July 6, 2011

**Re: Tailrace Flow for Proposed Project to
Build a Hydro-electric Generating Station at the North Bala Falls**

Figure 1 – Satellite View of Moon River, Showing Current and Proposed Flow

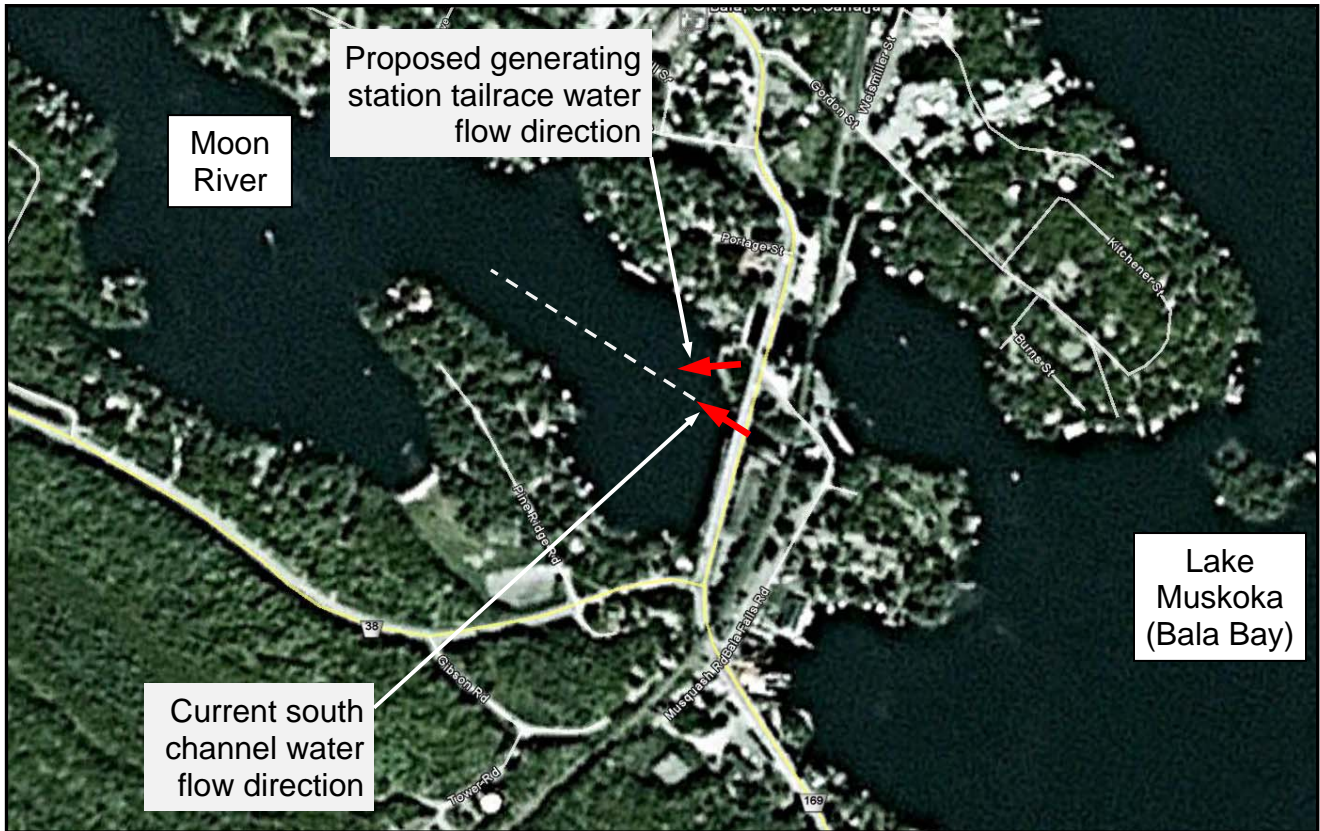
- 1) By adjusting the south dam stop-logs, Ministry of Natural Resources staff direct most of the water from Lake Muskoka to the Moon River over the south dam and through the south channel. Due to the shape and orientation of the south channel, the water is then directed down the centre of the Moon River. This current flow is shown in Figure 1. However, due to the orientation of the proposed hydro-electric generating station at the Bala Falls, the water from the tailrace would be directed at the south shore of the Moon River, as shown in Figure 1.

Unaddressed impacts of this flow of fast water directed directly at the shore include:

- a) Navigational difficulties for boats on the Moon River (pushing them to shore rather than down-river).
- b) Impinging the riparian rights of those on the south shore of the Moon River, as swimming and boat docking would become dangerous.
- c) In the spring, direct the ice break-up at the shoreline, or create a gyre in the bay of the Moon River south of the south channel, risking damage to shoreline property such as docks and boat houses.

- a) "Velocity in the outfall area will ... be directed straight downstream".
 - **This is a misinterpretation** of Figure 6.2b (largely because the proponent does not include the shorelines of the Moon River). Looking at the angle of flow relative to the orientation of the north dam as shown in Figure 6.2b, and the Satellite view in Figure 1 above shows that the flow **would not** "be directed straight downstream".

- The proponent needs to expand the boundary of their River2D simulation to include the south shore of the Moon River.
- Any conclusions about marine navigation must be done using flow regimes which are actually used.

Figure 2 – Proponent's Flow Simulation

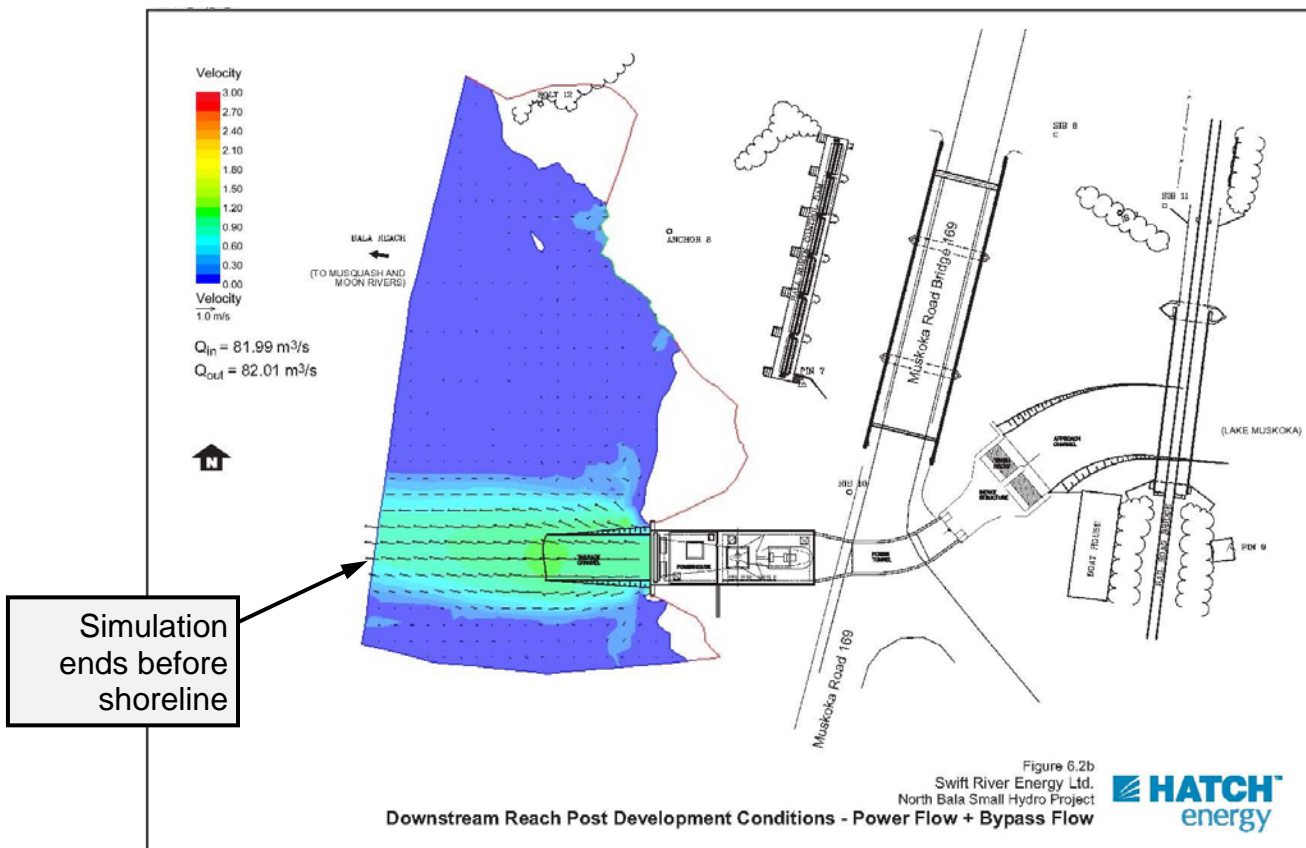
We note that Section 6.2.2.3 of the proponent's environmental screening report notes "flow velocity and vector are significantly altered downstream from the North Bala Dam due to flow diversion through the powerhouse" and that Figure 6.2b in their environmental screening report presents a River2D simulation of this (reproduced as Figure 2 above). Note that Figure 2 does not include the south shore of the Moon River, and also that the proponent notes "The flow plume from the tailrace exits the model boundary traveling in a westerly direction at a velocity of approximately 1.0 m/s."

That is, the proponent's proposed project would direct all the water exiting the tailrace at the south shore of the Moon River, the proponent states this would be a high velocity of water, and yet they do not complete the analysis to show the impact on the whole of the Moon River in this area.

- b) "... This will remove the circular flow patterns that exist and should make navigating a small vessel easier and more predictable".
 - As can be seen by observing the Moon River, the existing flow from the south channel is in fact straight downstream. There is no circular flow pattern.
Transport Canada has assumed that Figure 6.2a is the current situation and it is not.

- b) The simulation shown in Figure 6.2b **needs to be extended** to include the south shore of the Moon River as this is where the flow would change direction and a gyre may therefore result outside of the shown simulation.
